LARAMIE COUNTY PLANNING & DEVELOPMENT DEPARTMENT

MEMORANDUM

TITLE: PUBLIC HEARING regarding a Zone Change from A2 – Agricultural to AR

- Agricultural Residential and a Subdivision Permit & Plat for Roundtop Ranch Estates located in a portion of the W1/2, Section 10, T.14N., R.67W.,

FINAL PLAT FOR ROUNDTOP RANCH estates

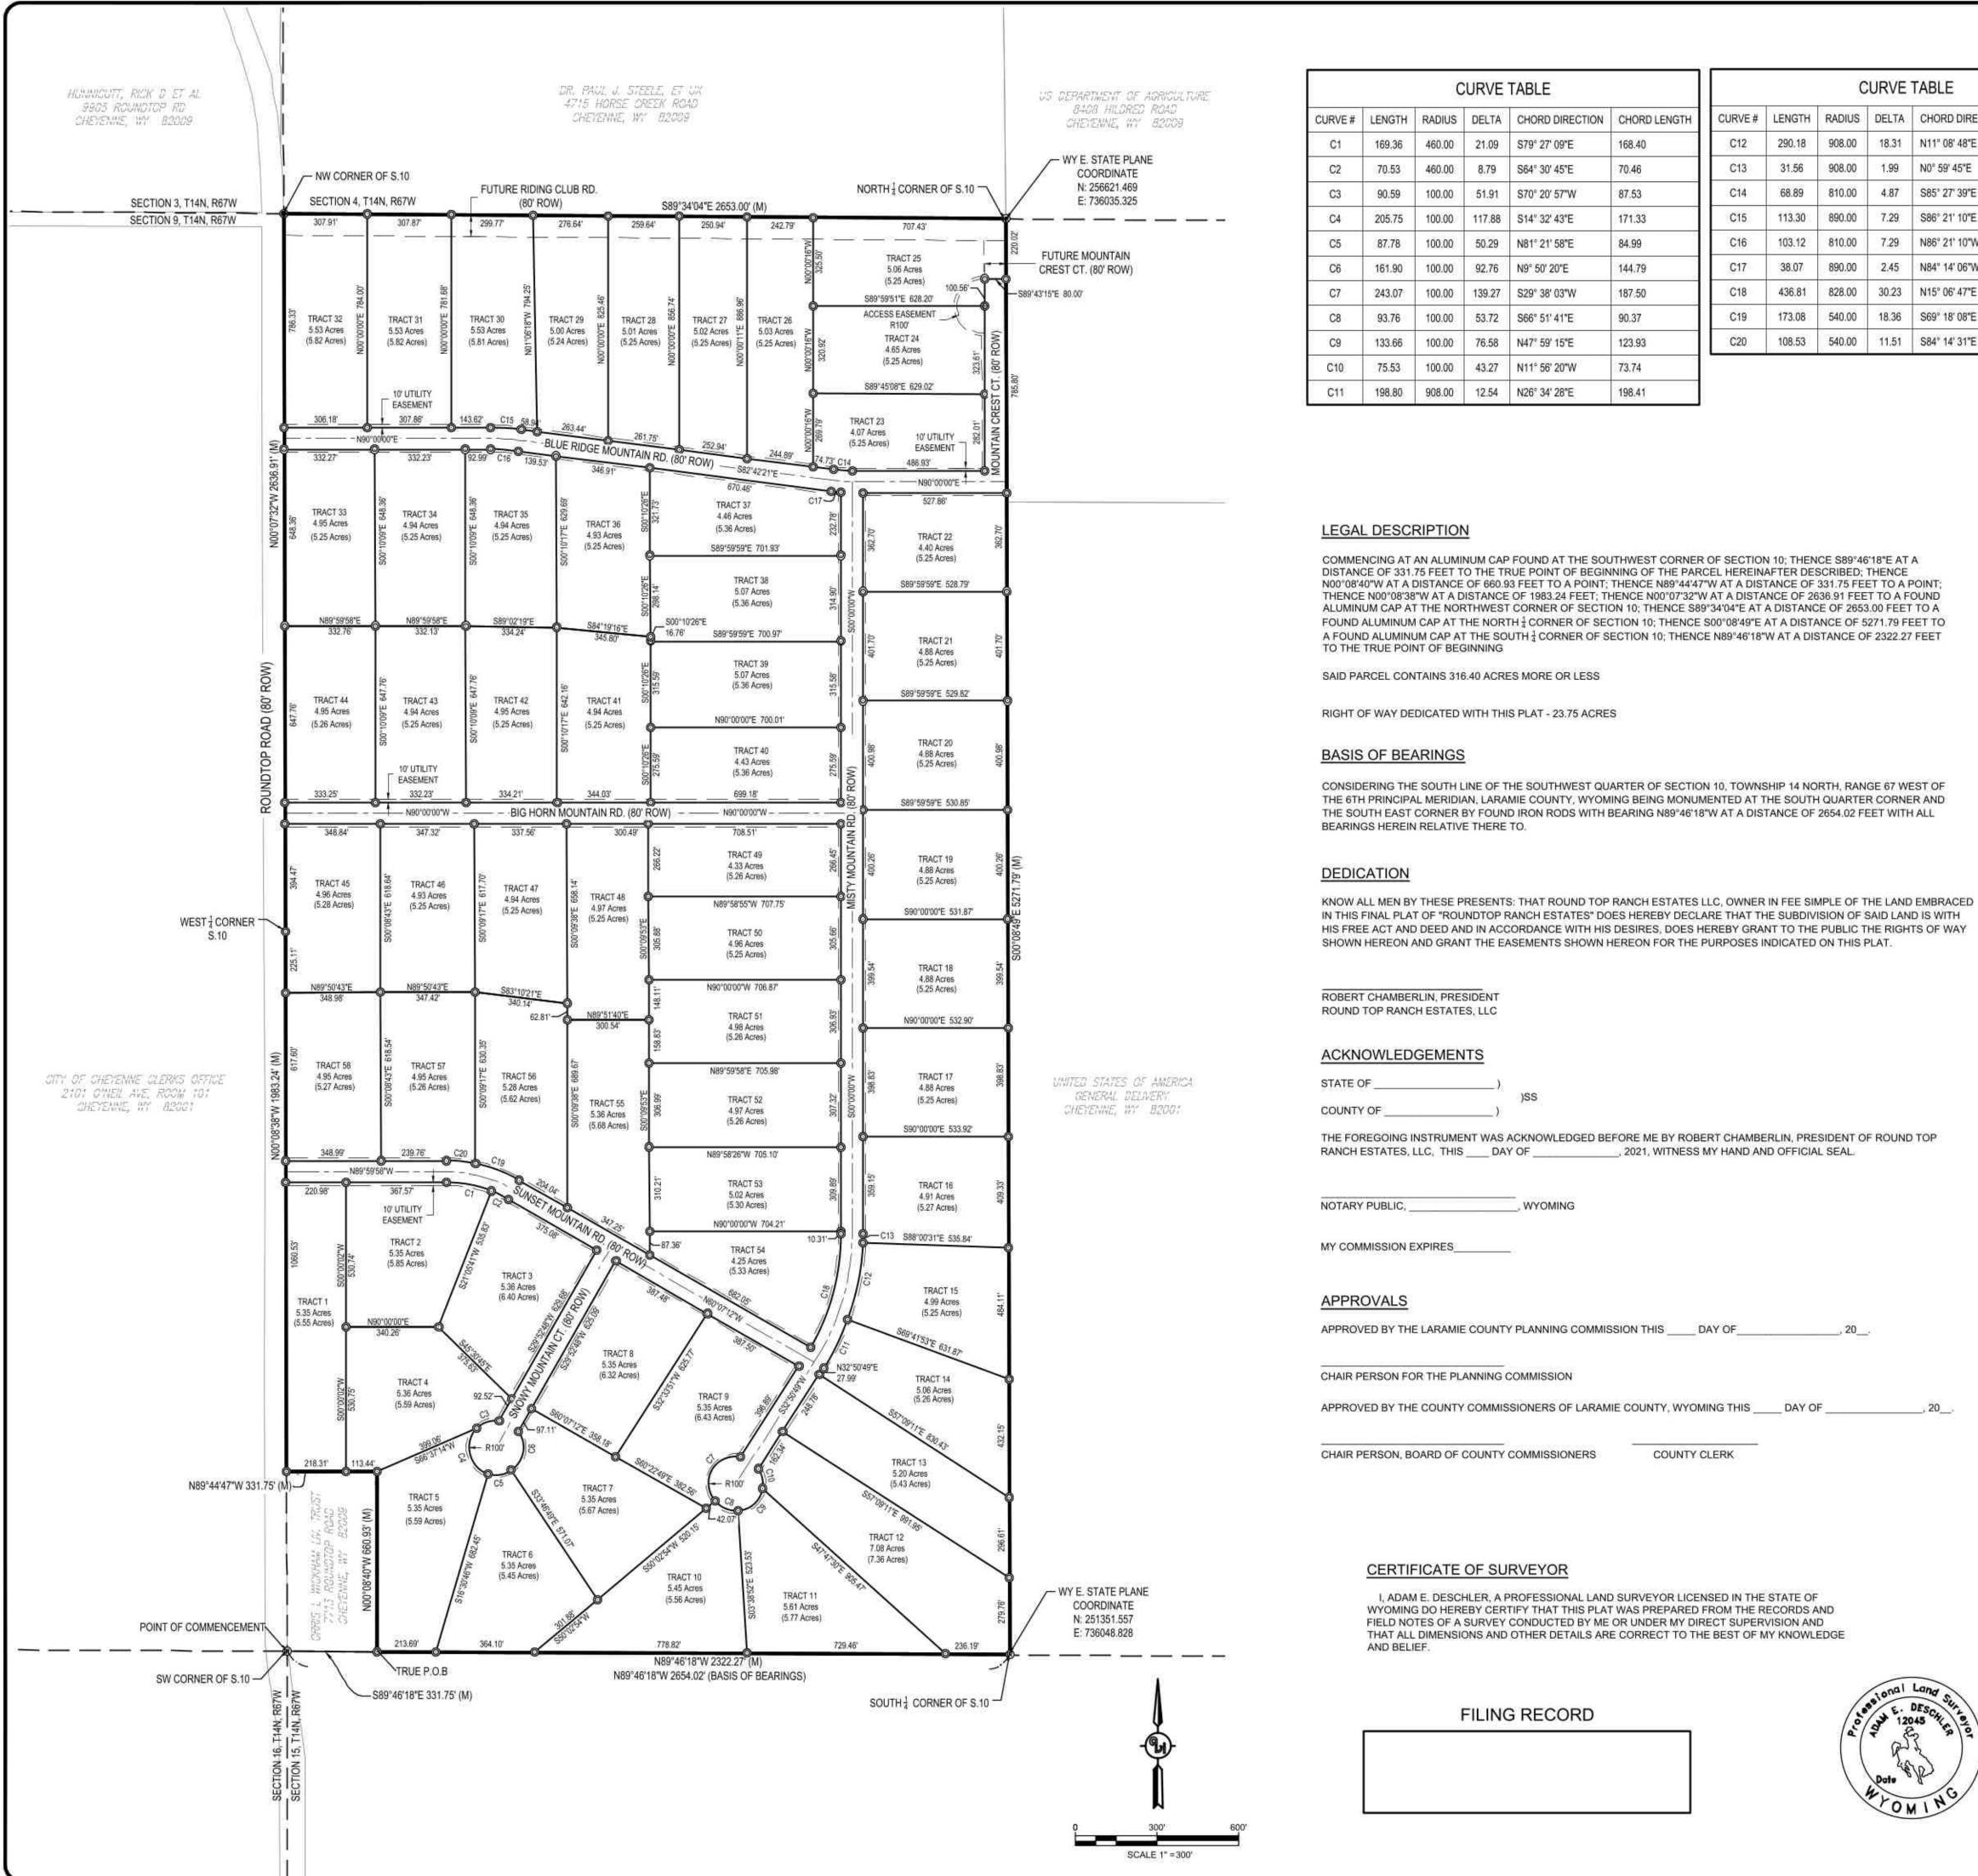
- 1. Tract 59 shall be extended to the east end of the development and shall be right-of-way of W Riding Club Rd. This roadway W Riding Club Rd shall be built with this development.
- 2. All three access roadways south of the NW Corner of S.10 along Roundtop Rd shall be shifted south by a length of approximately 650 feet to account for the future W riding Clube extension.
- 3. Mountain Crest Circle will extend to attach to the future W Riding Club Rd. A turn around for emergency vehicles shall be connected to W Riding Club Rd.
- 4. A traffic study shall be submitted since this development will be generating approximately 580 trips a day.

<u>County Assessor:</u> County Assessor, Kaycee Eisele Comments Attached 05/06/2021 At the beginning of the legal description, it states "Commencing at an aluminum cap found at the SOUTHEAST corner of section 10". According to the assessor records and for the purposes of your plat, this parcel is starting at the SOUTHWEST corner of section 10, as indicated on the actually map portion of plat.

Robert Chamberlain's signature with printed name must be accompanied by his affiliated title for Roundtop Ranch Estates LLC, as it also should in the notary acknowledgement, which was included on this plat.

<u>County Attorney:</u> County Attorney, Joe Chenchar Comments Attached 05/18/2021 1. In the Dedication, please include the name of the business entity that owns the parcel, which Mr. Chamberlin is the agent of.

2. Note 3 refers to Powderhouse Rd., I do not believe this is applicable to this plat.

The deed where they took title has Round Top as two words. Please change the notary acknowledgement, and add Roberts title and the company name after his printed name below where he is to sign.

1. The Drainage Study submitted is adequate for this submittal. A final Drainage Study will be required with the roadway construction plans to address culvert sizing, etc.

- 2. There is an existing drainage path through the southern portion of the platted area. The engineer needs to evaluate the paths for this drainage and the roadside ditches to determine where drainage easements will be needed to allow the runoff to travel through the various Tracts. The drainage easements need to be included on the plat drawing.

- 3. Based on the Traffic Study submitted, and previous comments made during the PDP submittal, the developer will be required to pave Roundtop Road from Rocky Mountain Road north to Horse Creek Road since the average daily traffic will far exceed 350 vpd. The paving of the roadway shall meet the current LCLUR. I concur with the findings/conclusions of the Traffic Report.

- 4. Roadway design plans for all roadways (including the paving of Roundtop Road) shall be submitted for review and approval to the County.
- 5. There is no note regarding floodplains and referencing the FEMA panel for this area.

- 6. Note 3 is not applicable to this plat and should be removed.
- 7. On the north side of the Mountain Crest Circle cul-de-sac, there is a property/ROW line that has an 80' dimension but no bearing is listed.

- 8. What is the purpose of Tract 59? It is too small for a well and septic. If it is for potential future ROW (since it is shown as 80' wide) it should be platted as ROW now and extend all the way to the east. This would line up nicely with West Riding Club Road if property to the east is ever developed.

- 1. There are no Wyoming State Plane field observation coordinates shown for the Northwest Corner or the West 1/4 Corner of Section 10.
- 2. In the BASIS OF BEARINGS note, should "SOUTHEAST CORNER" be "SOUTHWEST CORNER" and should the referenced distance be "2654.02" (the actual length of the line referenced between the 2 referenced PLSS corners?

Wastewater permits are required for each lot. All small wastewater systems must have a 50' setback from all property lines and intermittent bodies of water i.e. drainages and floodplains. A DEQ letter and Chapter 23 report must be submitted to this office along with the signed final plat prior to application for any permits.

Proposed "Shadow Mountain RD" should be renamed to avoid confusion with similarly named roads already in existence - Shadow Mountain Trl and Shadow Mountain Cir.

<u>Intraoffice:</u> Planners, Cambia McCollom Comments Attached 05/07/2021 5/7/2021: A review of the proposed road names brought up a number that would not be considered unique from existing or currently/previously proposed roads. Please consider alternative names for:_Mountain View Shadow Mountain Rocky Mountain

Note #3 does not appear to be applicable to this plat.

<u>Building Dept.:</u> Building Dept., Antony Pomerleau Comments Attached 05/11/2021 Fire apparatus access roads shall be designed to meet all applicable sections of the 2018 IFC chapter 5.

Half of the property falls within the 5 road mile range to the nearest station. The other half of the development is out of the 5 road mile range thus creating the need for a water supply source.

- 1. Snowy Mountain Circle and Mountain Crest Circle will need to be renamed as "Circles" are not permitted in road names.
- 2.The field observation coordinates must reference Wyoming State Plane Coordinate System, East Zone, US Survey foot, NAD 1983.
- 3. The correct FEMA Panel must be included on the plat.
- 4. Note 3 needs to be updated for this plat It appears to be a copy and paste error and refers to the wrong roads.
- 5. This property appears to be in the Low hazard level of the CWPP area. A note must be added with this information.
